WINSOME FILING NO. 3  
PRE DEVELOPMENT GRADING AND EROSION CONTROL PLAN  
A PORTION OF SECTIONS 13 AND 24, TOWNSHIP 11 SOUTH, RANGE 65 SOUTH, AND  
A PORTION OF THE WEST HALF SECTON 19, TOWNSHIP 11 SOUTH, RANGE 64 WEST OF THE 6TH P.M  
COUNTY OF EL PASO, STATE OF COLORADO

# Grading & Erosion Control Plan\_V2-redline.pdf Markup Summary

WINSOME FILING NO. 3  
EL PASO COUNTY, COLORADO  
PRE DEVELOPMENT GESC PLAN  
CULVERT PLAN & PROFILE

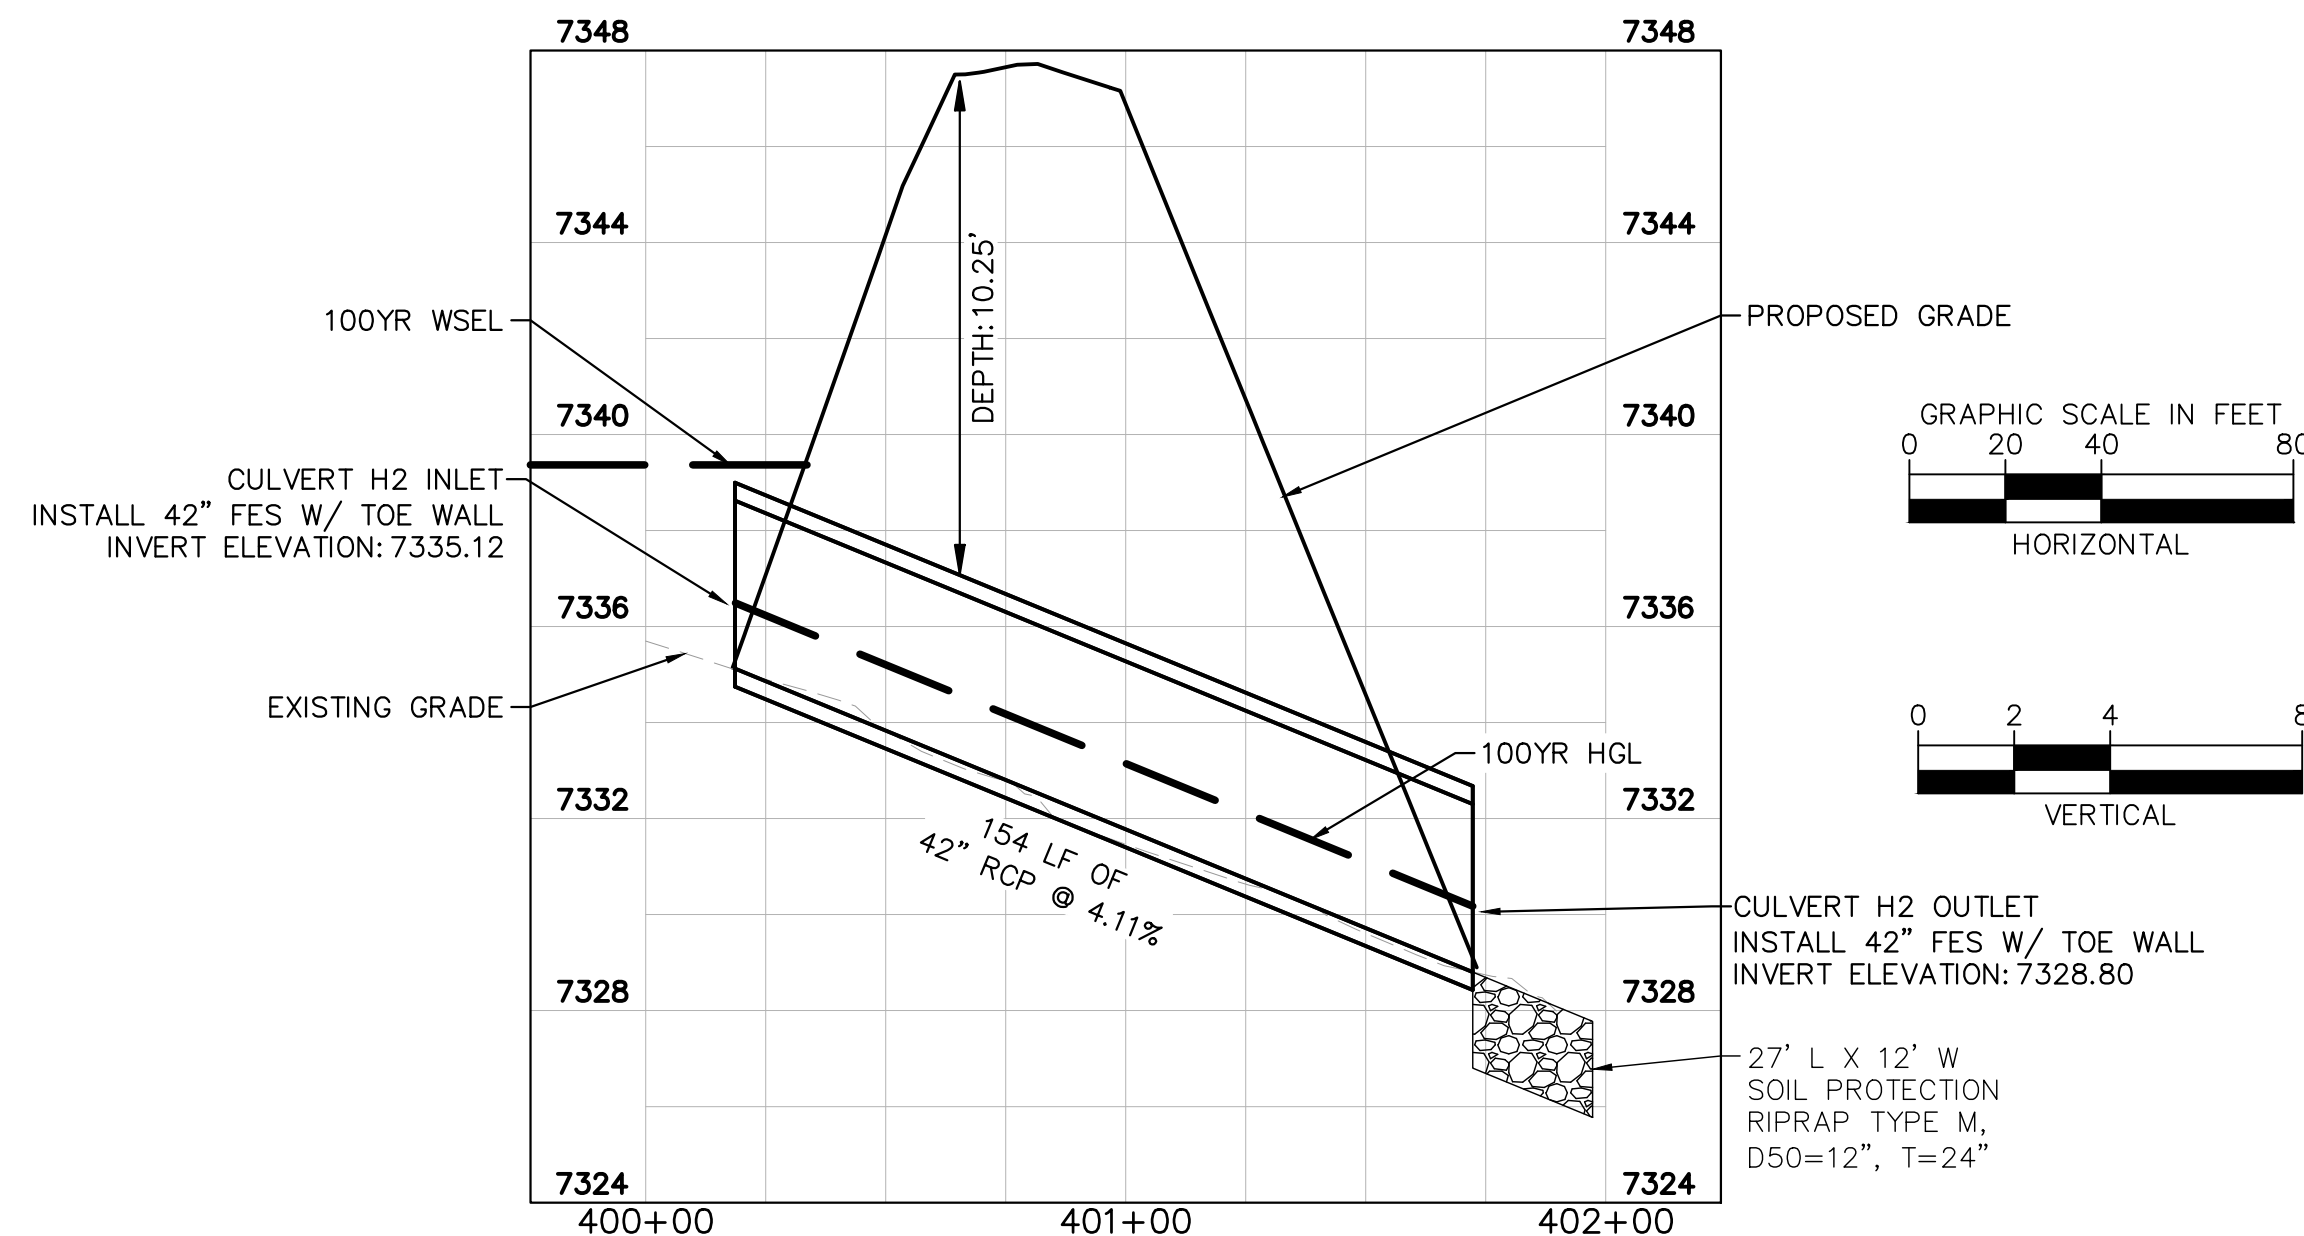
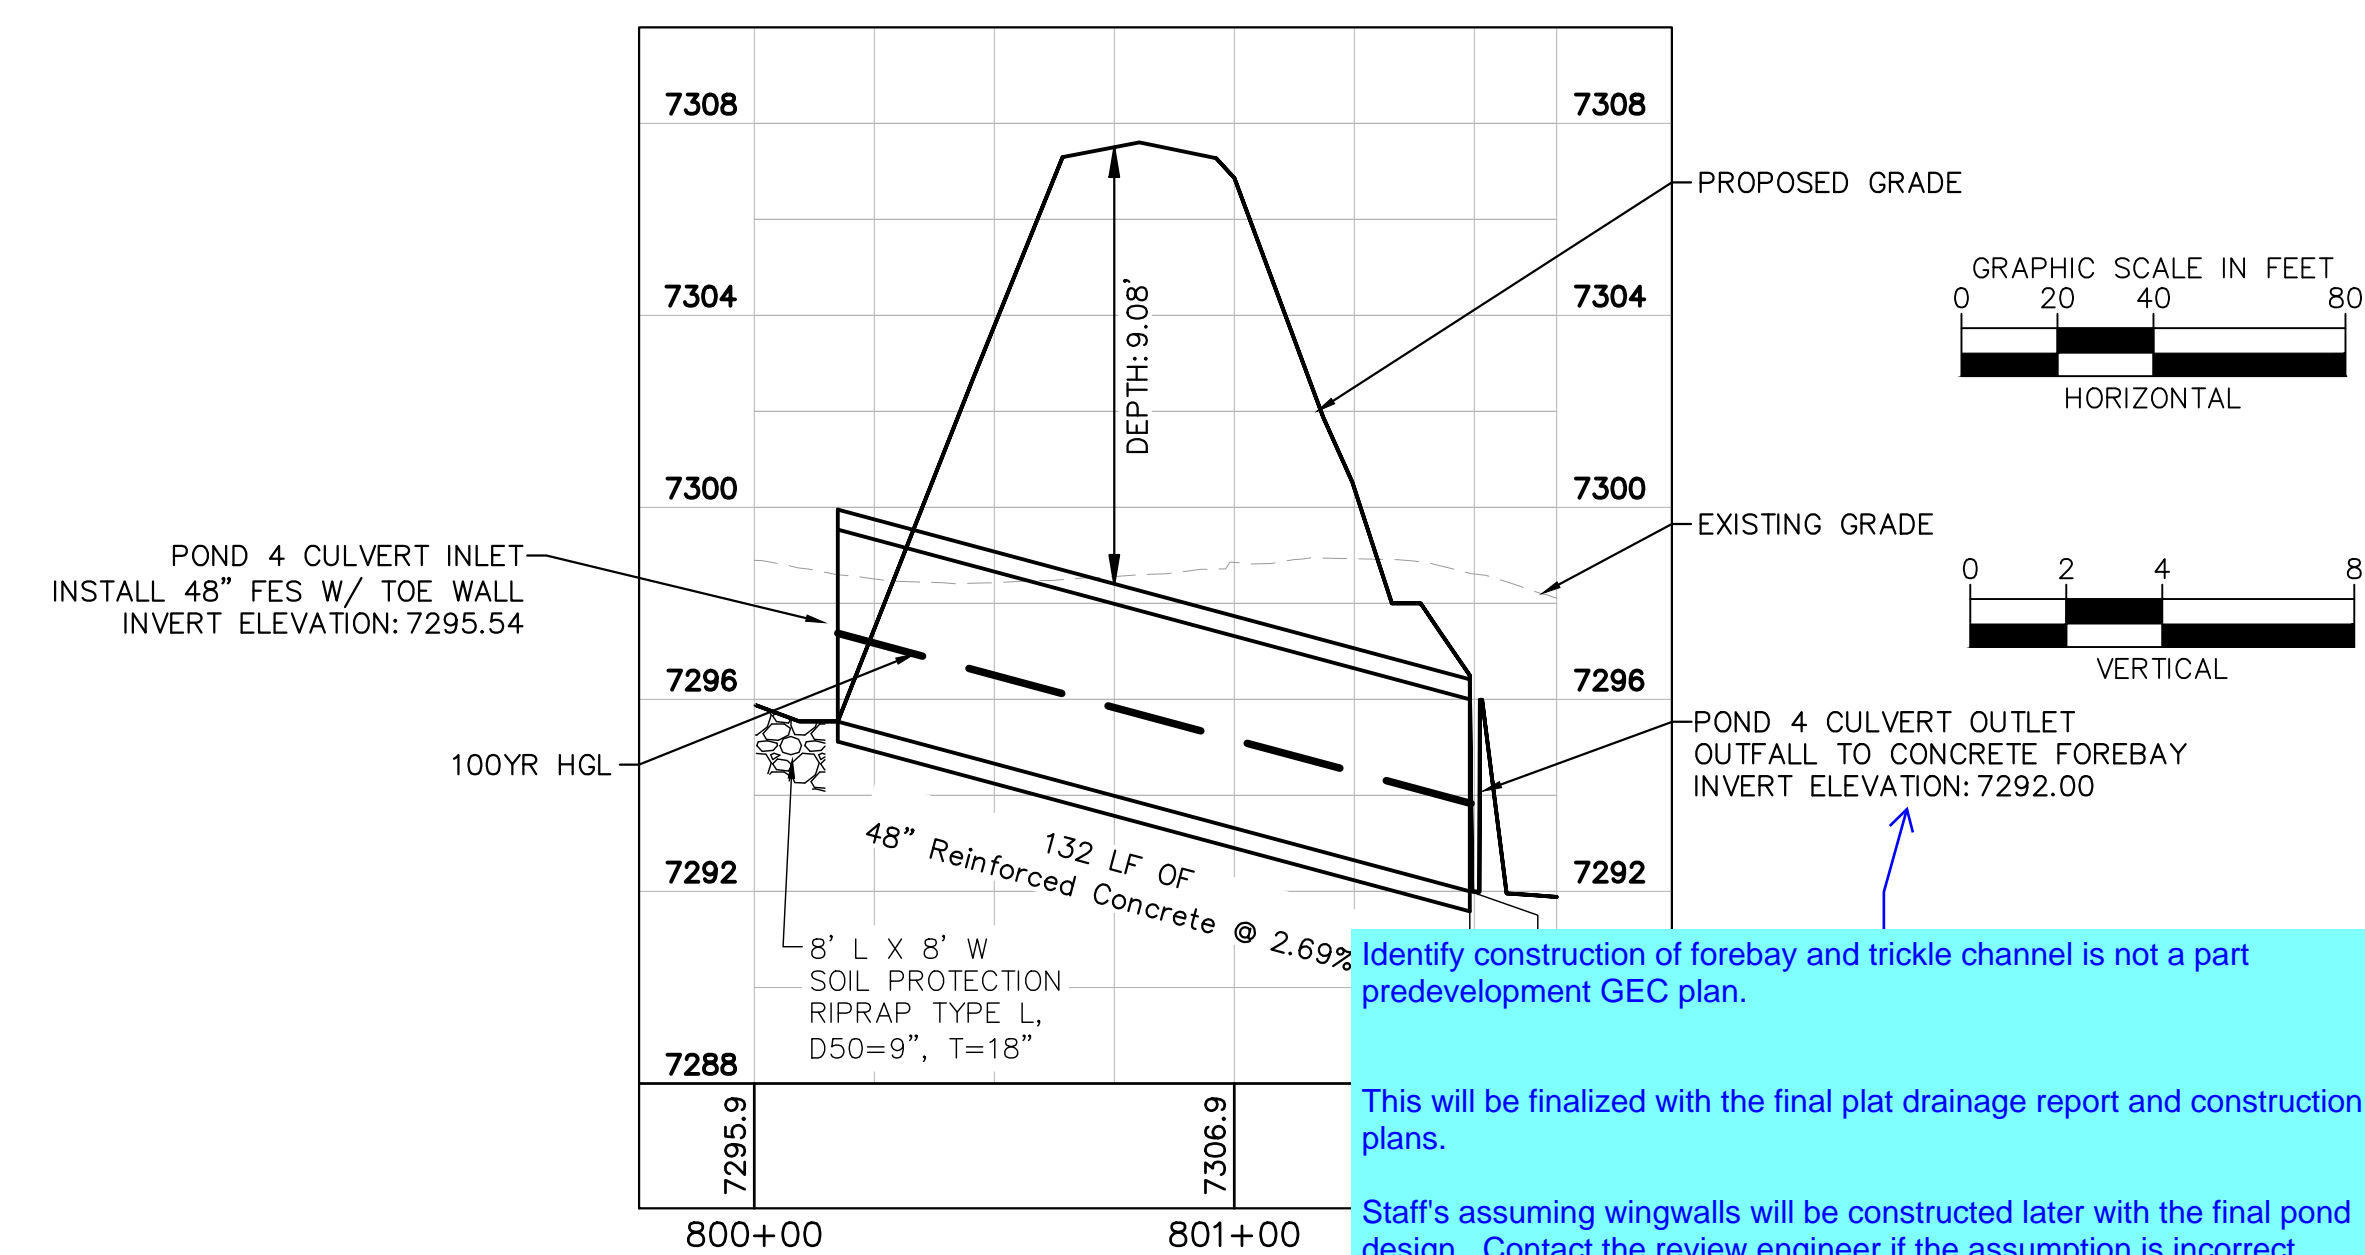
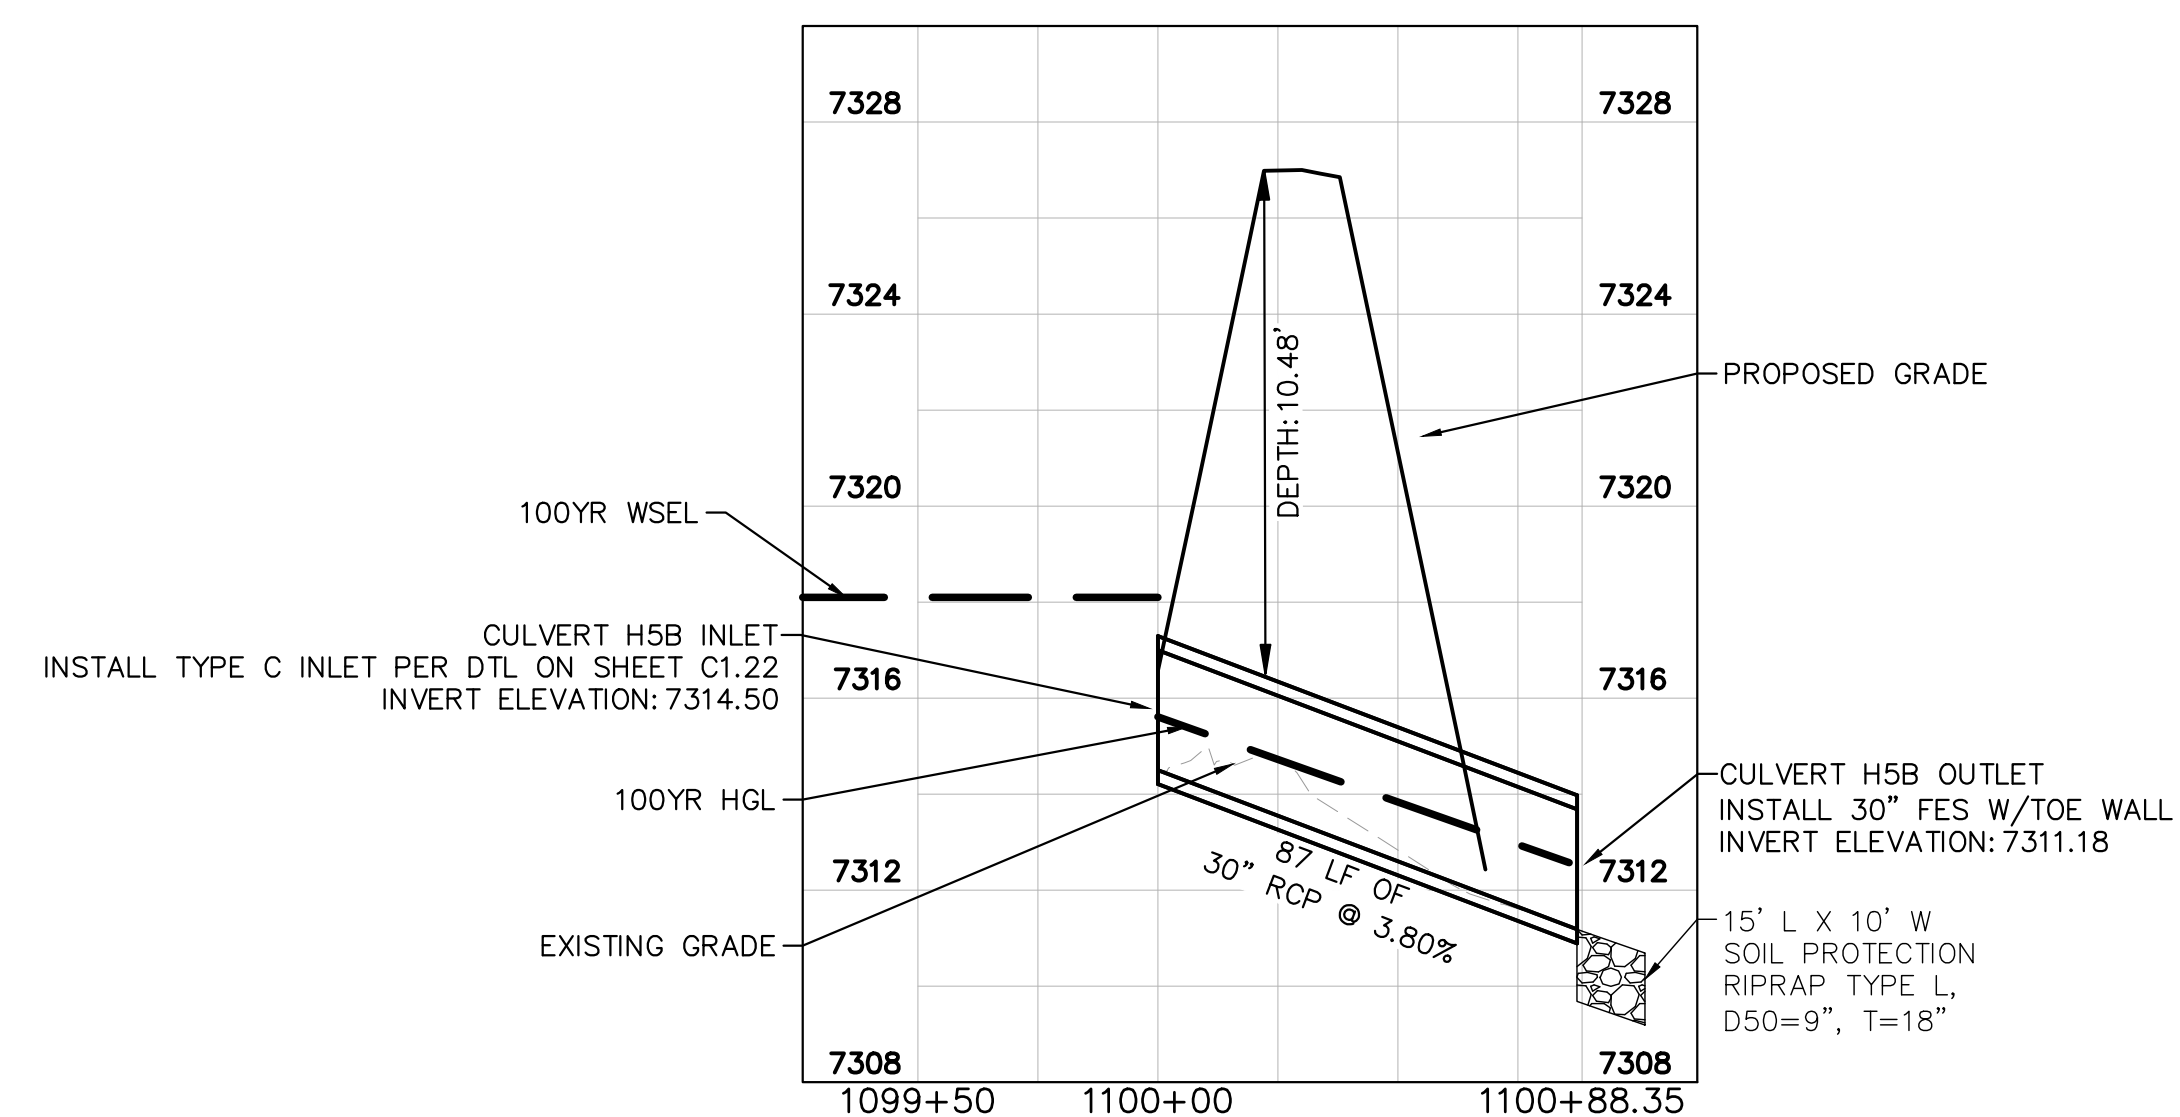
69% Identify construction of forebay and trickle channel is not a part predevelopment GEC plan.

This will be finalized with the final plat drainage report and construction plans.
